Freshwater Mixed Use Development

50 Lawrence Street
Freshwater, NSW

Development Application
SEPTEMBER 2021

March Shadows 9am
SCALE 1:250 @ A1

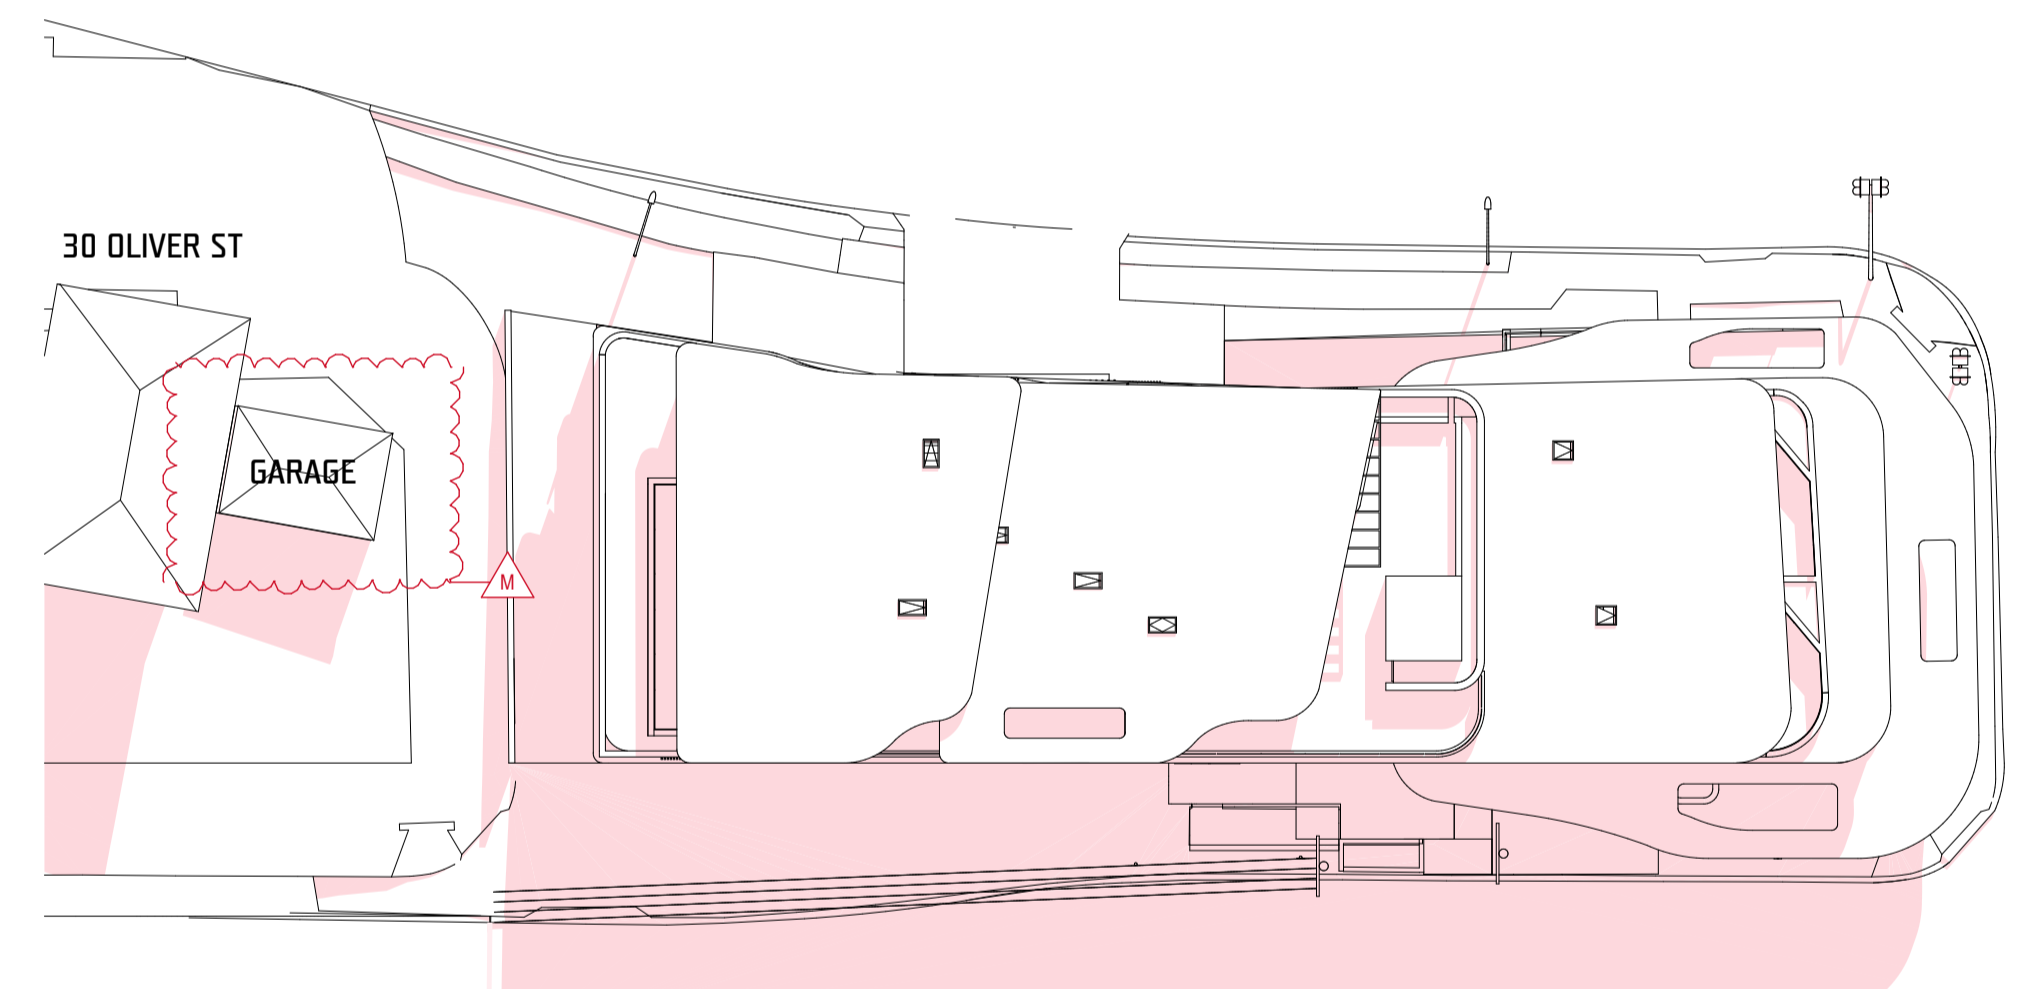
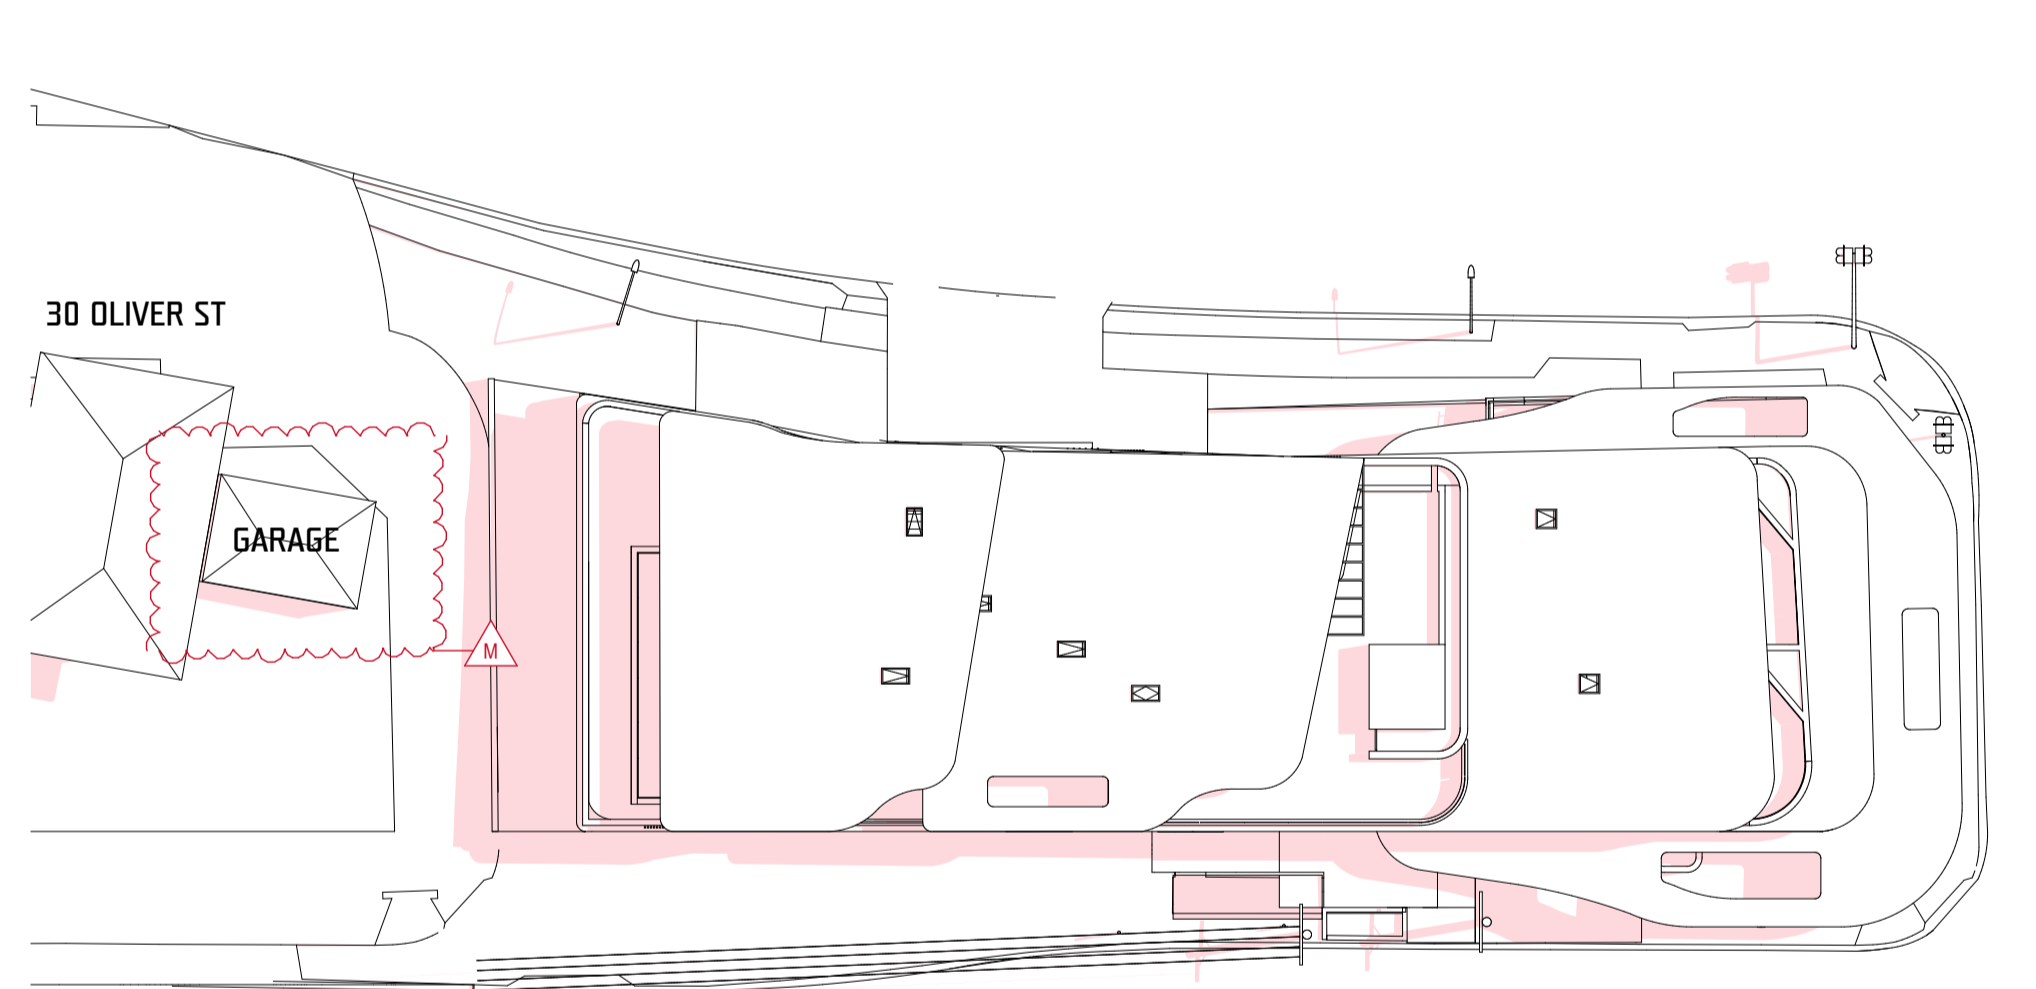
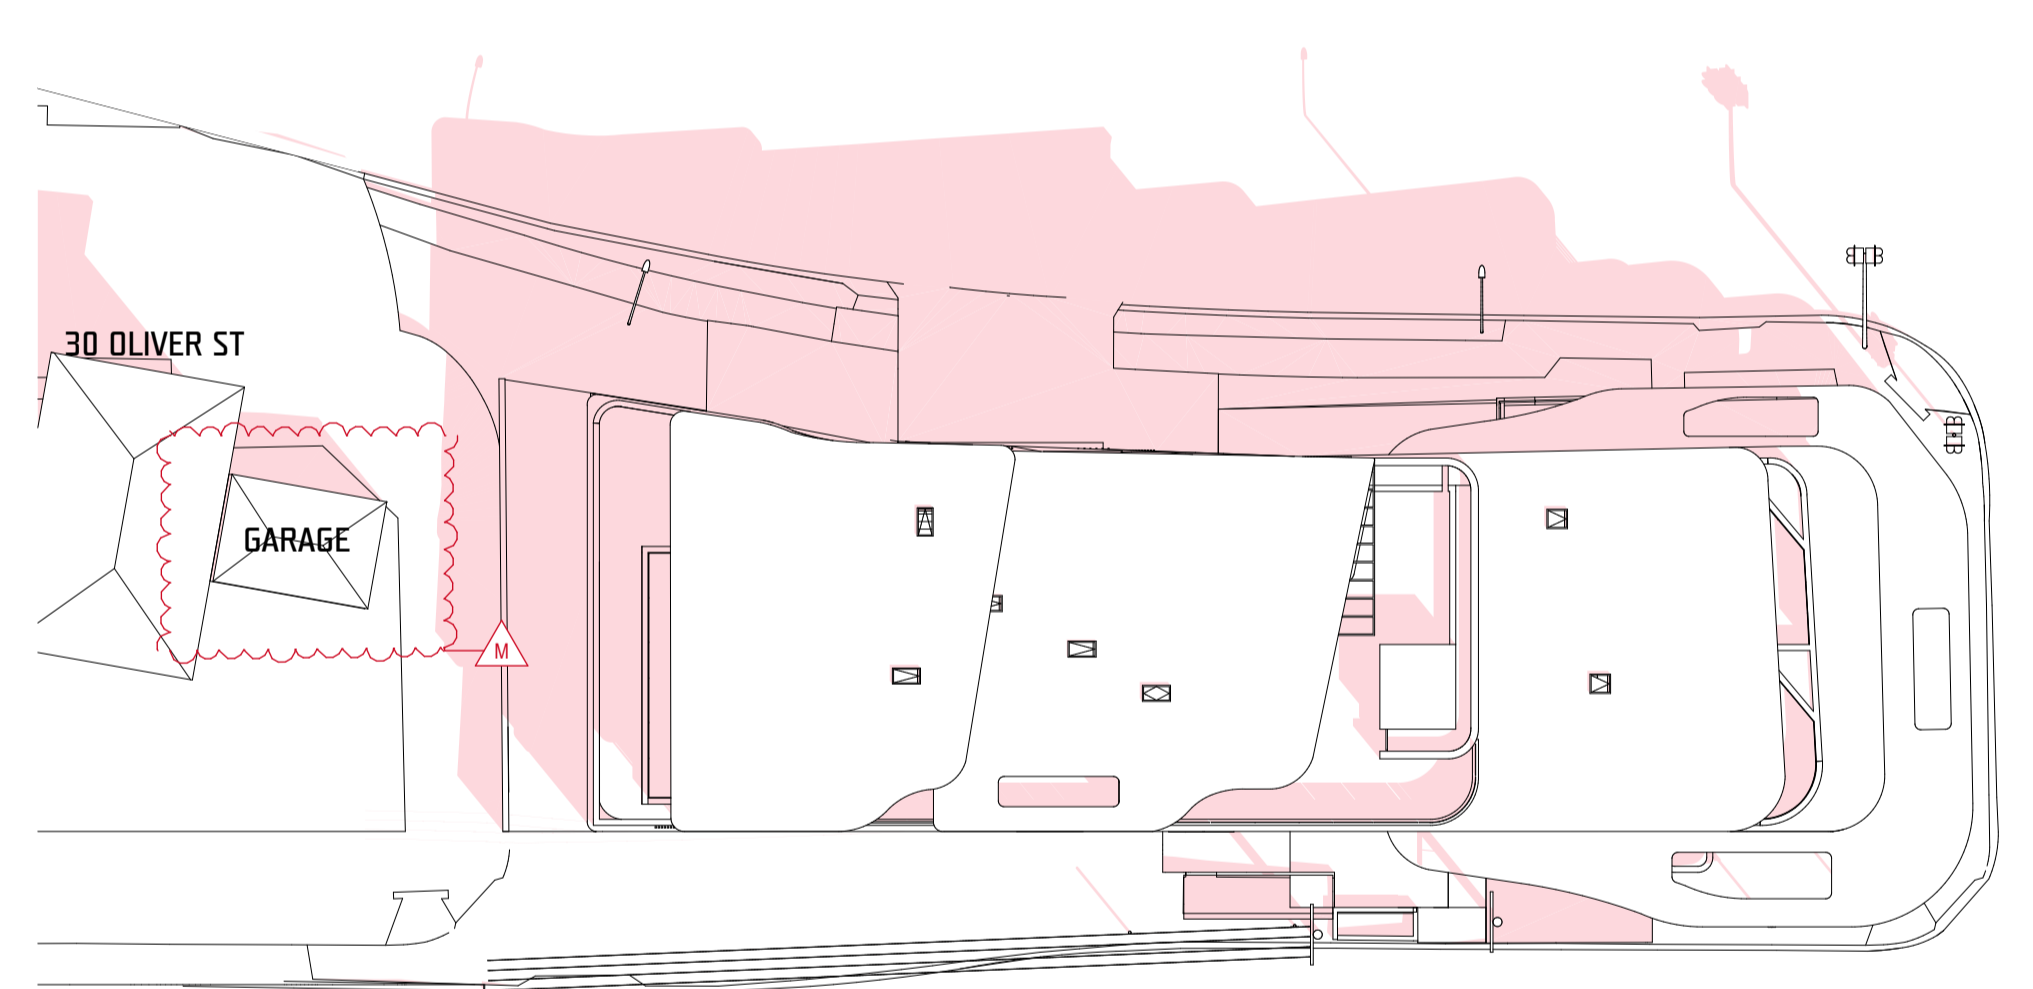
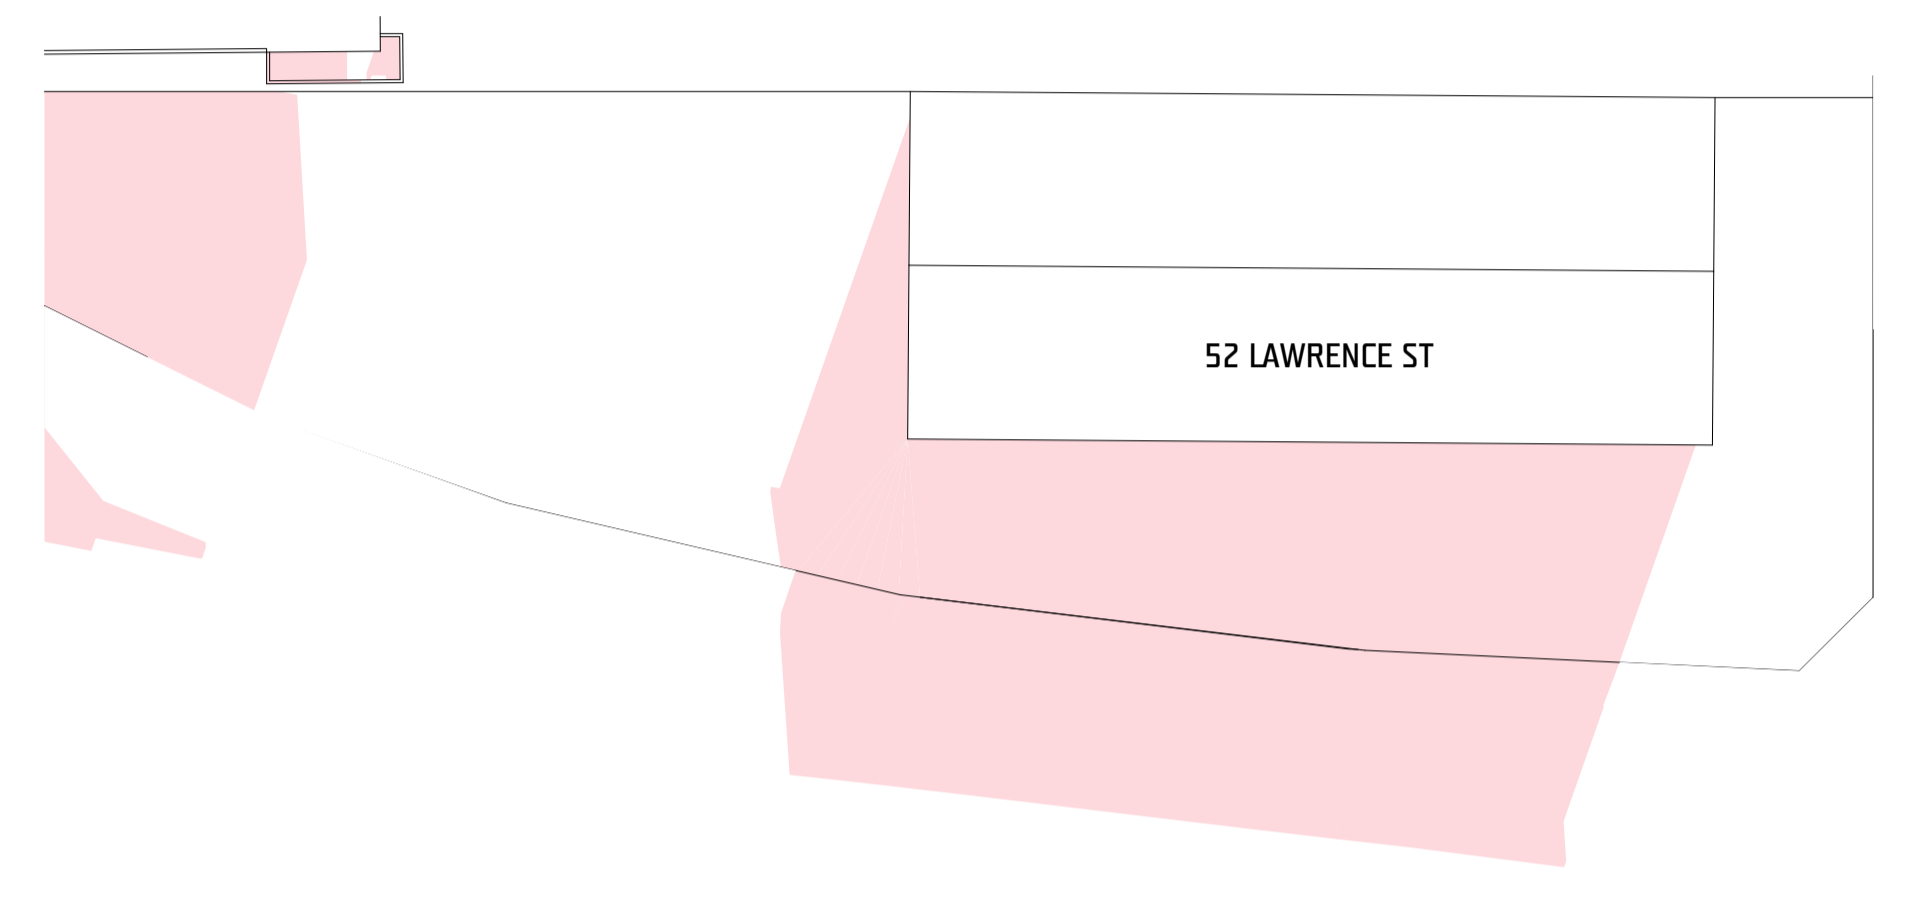
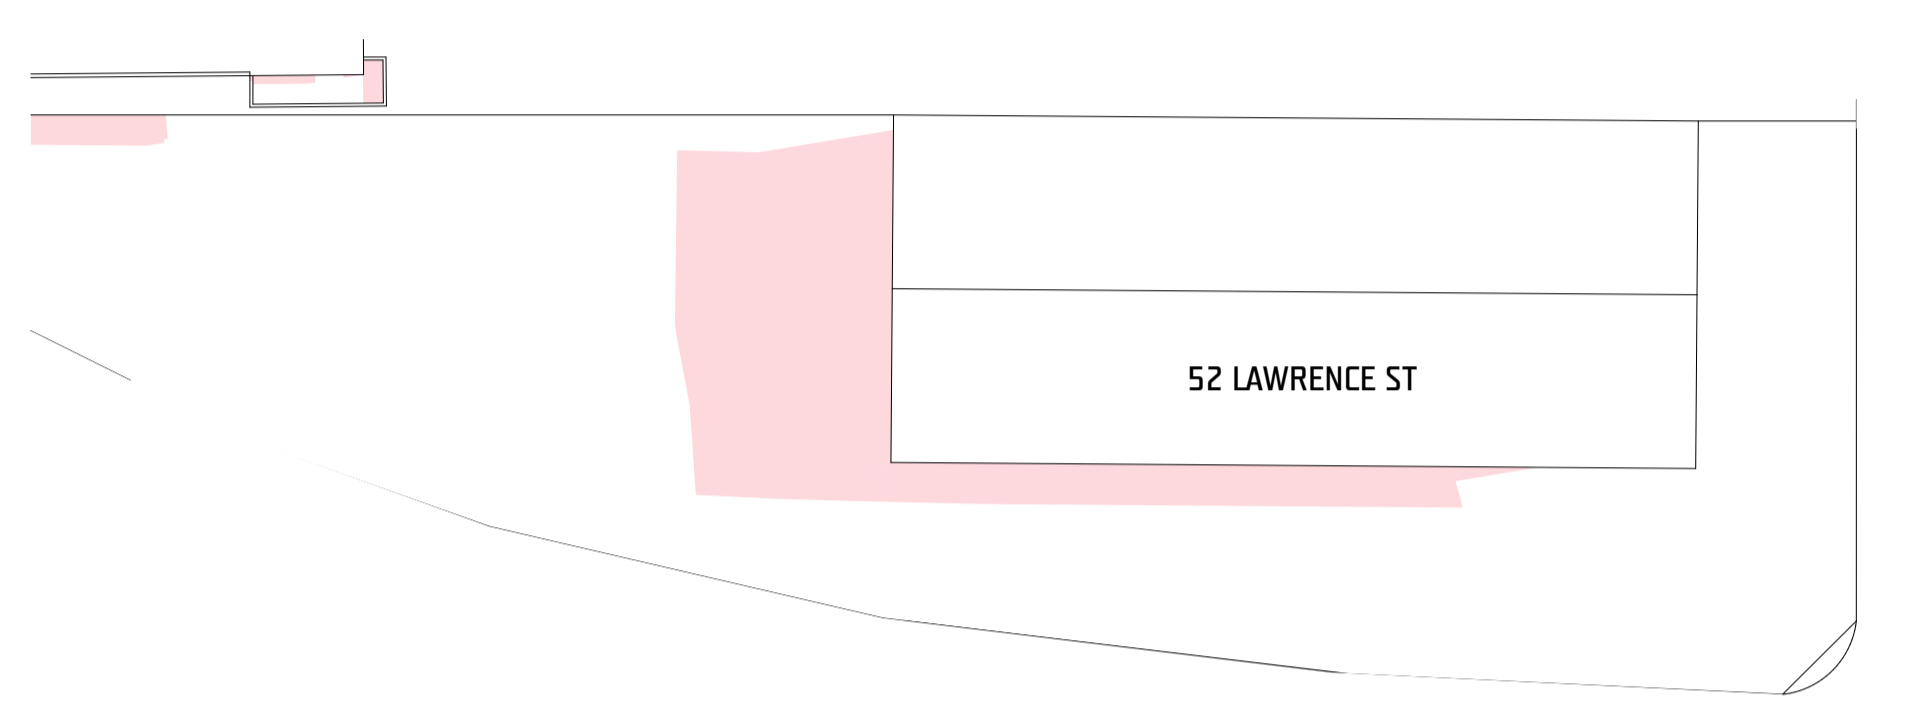
M: Neighbouring Property- Existing garage added to plans for clarity.
